Errata: CS43L41 Rev. CCS43L41 Low Power 24-Bit, 96 kHz DAC with Volume Control

All references to the CS43L41 mentioned below shall be taken to refer to revision C of the CS43L41 product. The hardware revision code can be found in the 10 character field printed below the part number on each chip. The letter which appears as the fifth character from the right is the revision code (e.g. ZNACSC9926 is a Revision C part).

Figure 1. I²C SCL Buffer Example

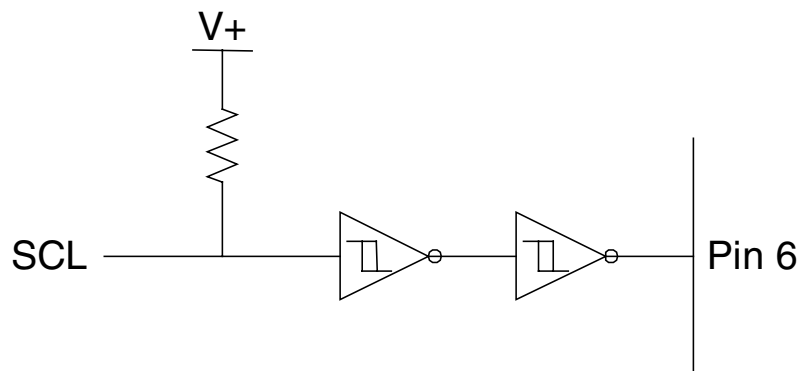
Pin 6 (SCL/CCLK) of the CS43L41 does not have sufficient hysteresis to meet the data sheet rise time specifications. The I²C rise time t_r and the SPI rise time t_{r2} must be less than 30 ns for proper operation. This prevents the use of standard I²C configurations with a resistor pull-up. This problem can be worked around by placing a Schmitt Trigger buffer, for example a 74HC14, on the SCL line just prior to the CS43L41. This will not affect the operation of the I²C bus as pin 6 is an input only.
